**Re: OFFICE OF LONG ISLAND SOUND PROGRAMS
Notice of Tentative Determination and
Notice of Coastal Consistency Review
Application #201005365-MG and FCC #201005371-MG
Towns of East Lyme and Waterford**

I am writing you on behalf of the East Lyme Public Trust Foundation, Inc. as its President. In response to your Department's call for comments on Application #201005365-MG and FCC #201005371-MG, and specifically to the applicant's proposed modification of a work trestle and installation of a temporary cofferdam, we appreciate this opportunity to document our position.

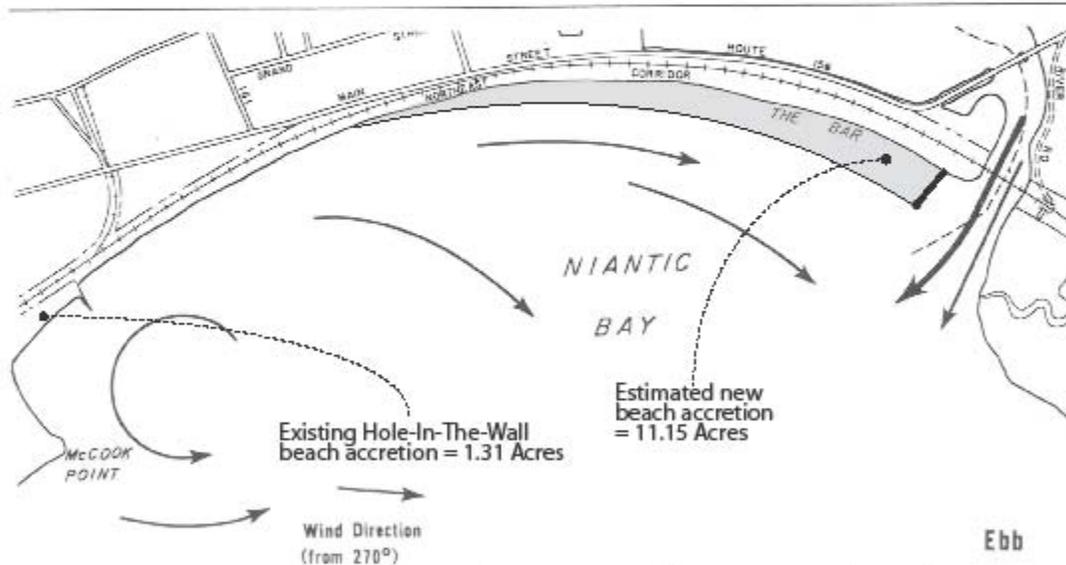
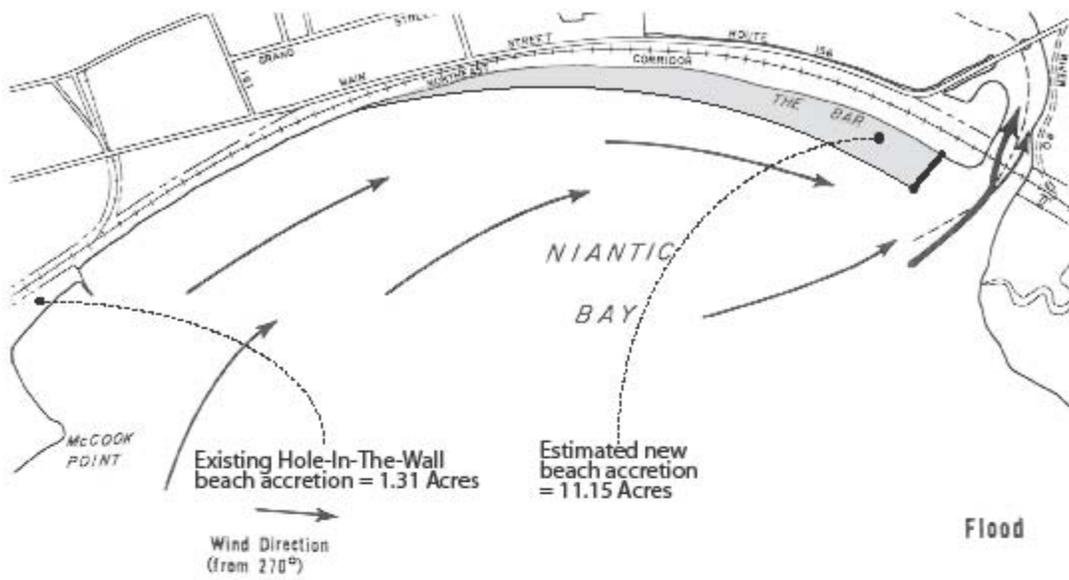
long-shore currents in Niantic Bay were consistently carrying sediments easterly (see Figure 1). Therefore, the proposed groin will function to trap and retain those sediments. Augmentation of that accretion by the addition of 73,000 cubic yards of sand, as specified in the existing permit conditions, is welcome but may not be needed if the project takes advantage of natural accretion resulting from the 2010-2013 storm seasons that will place sand on to the new groin-induced beach. Based on Figure 1 and the proposed groin design, I estimate that an 11.15 acre new beach will be created. The Amtrak request for modification to its Section 401 Clean Water Permit should be immediately approved in order to take full advantage of the 2010-2011 storm seasons. Once the groin is in place, the state, the community, and the Overlook Park will reap substantial benefits in the public trust by the reconstructed Overlook Park and its new beach, thus increasing free public access along the Connecticut coast line to Long Island Sound by approximately 10%.
